TECHNICAL INFORMATION REPORT

Fortress- Puyallup

240 15th Street SE
Puyallup, Washington 98372

7/27/2023

Figure 3
Critical Areas
Map

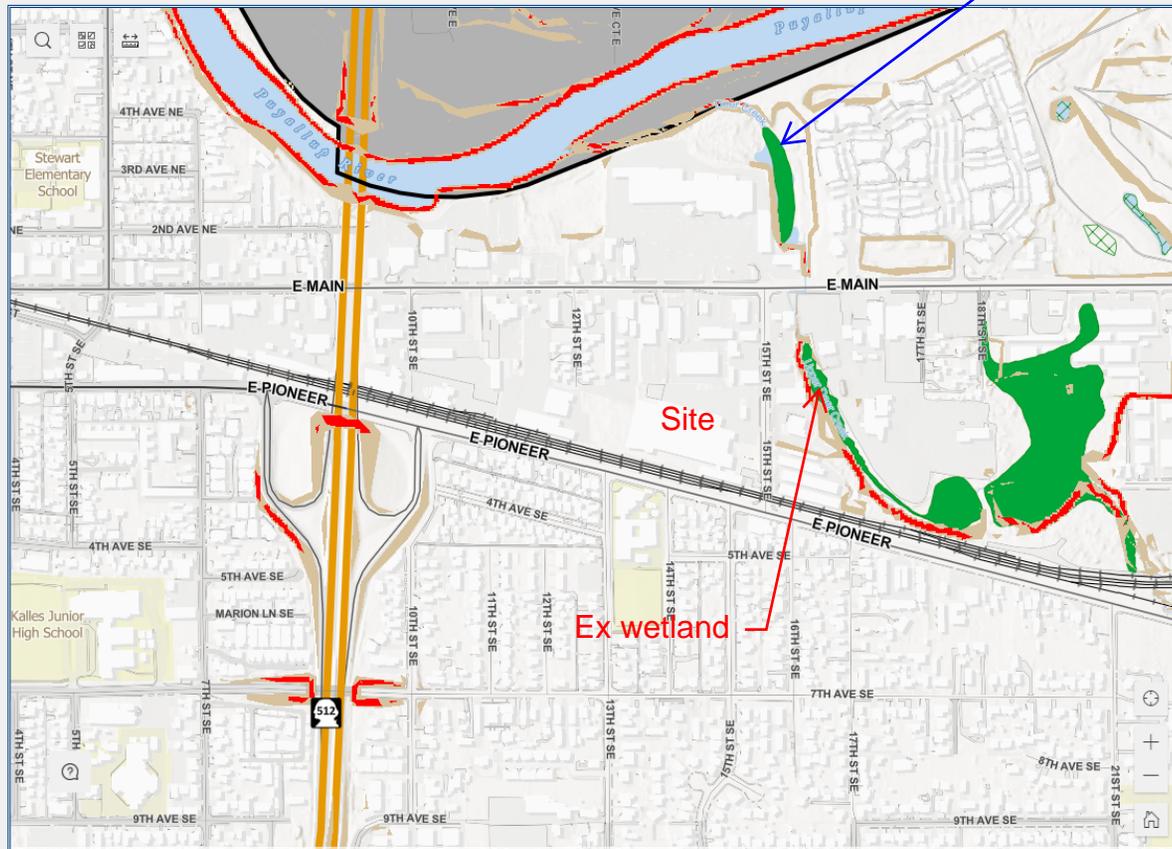
Show the existing wetland in which the project discharges too. [storm report, pg 11]

Figure 8
Wetland
Protection
WWHM Model

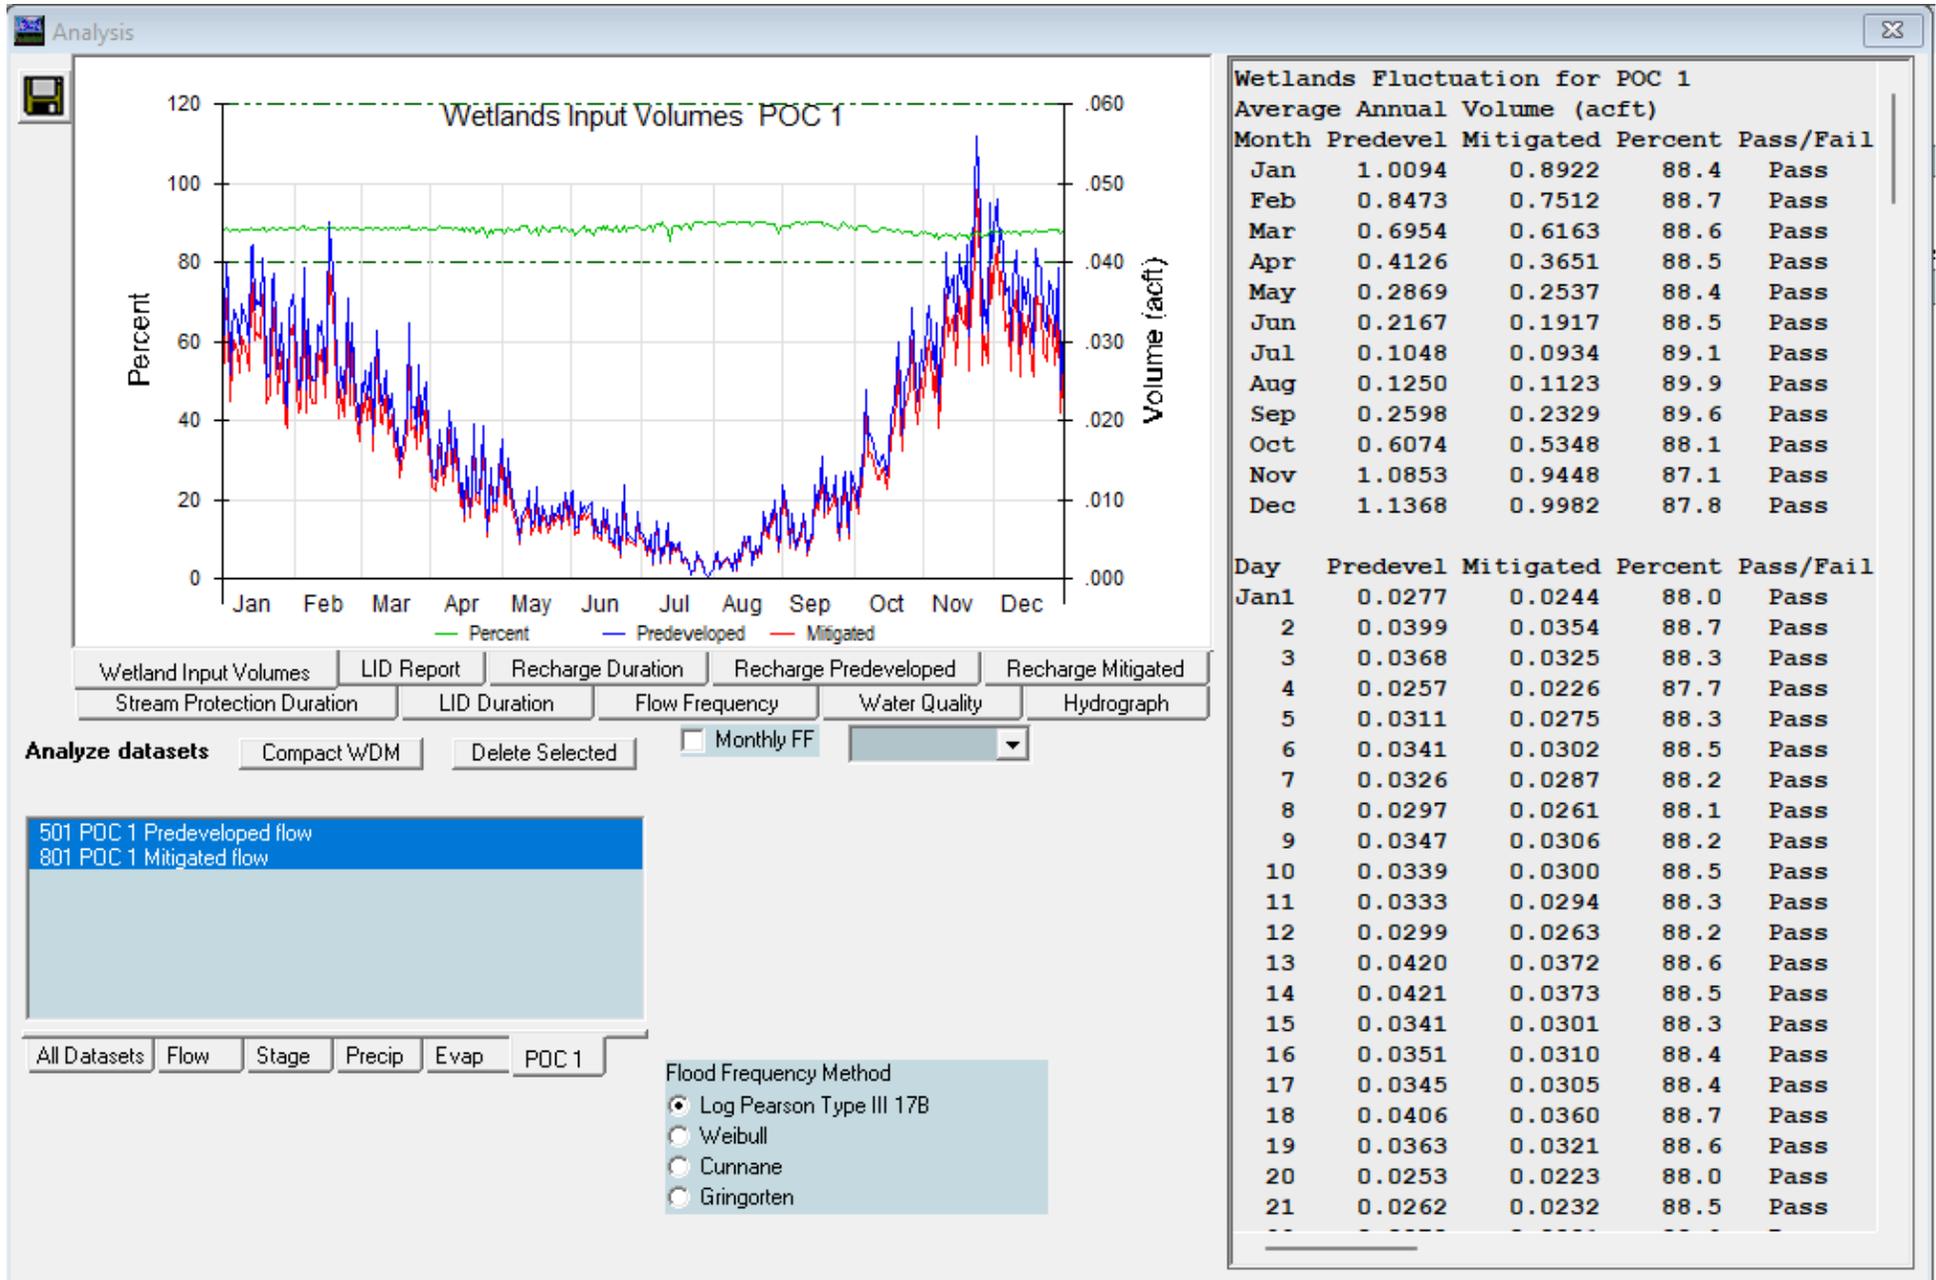
Pasture vegetation is reserved for rural areas where forest has been cleared and replaced with shrubs or grass lots. Revise the existing pervious conditions to be lawn vegetation. See III-2.2 Continuous Simulation Models within the DOE manual for more information. [drainage report, pg 75]

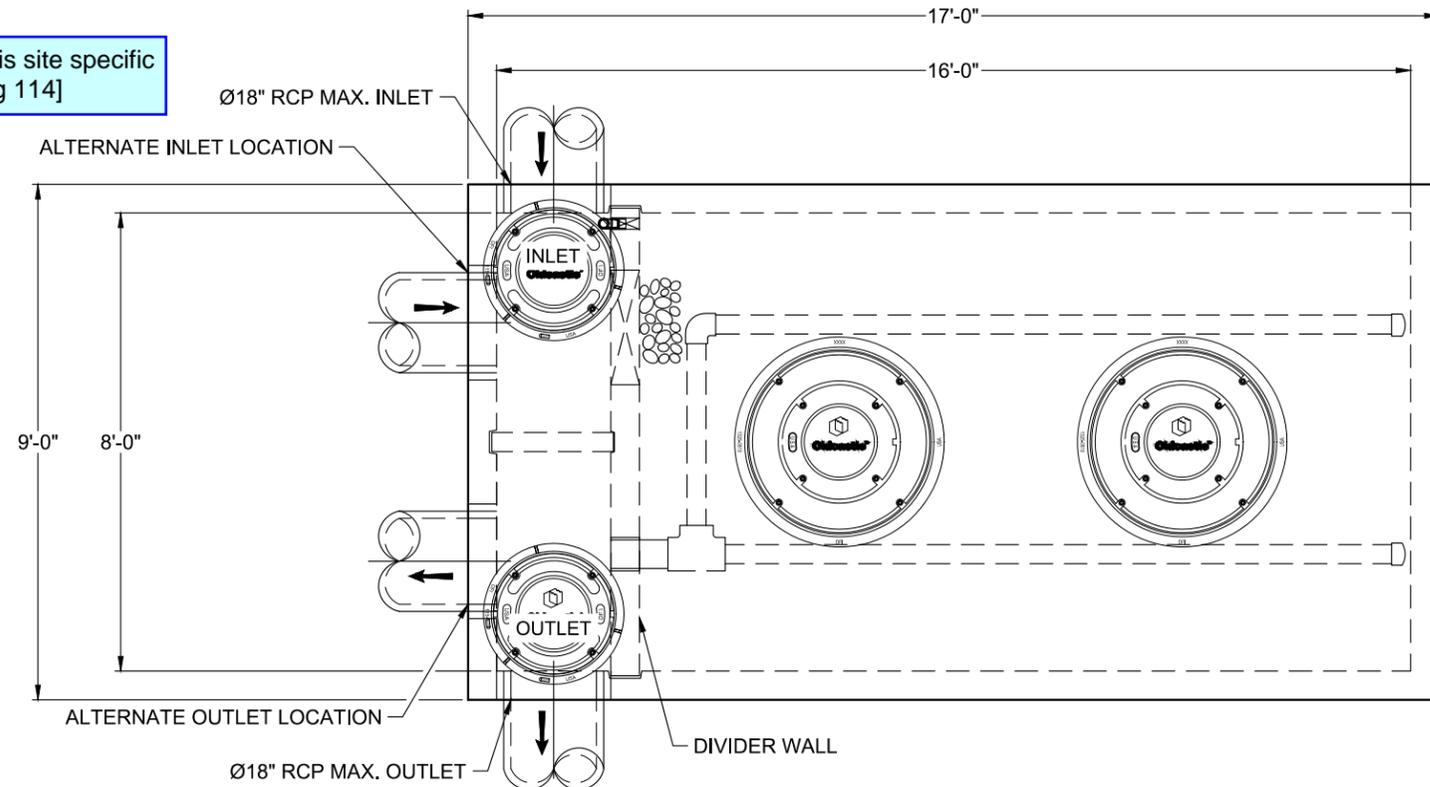
Fill out the rest of this site specific data chart. [civils, pg 114]
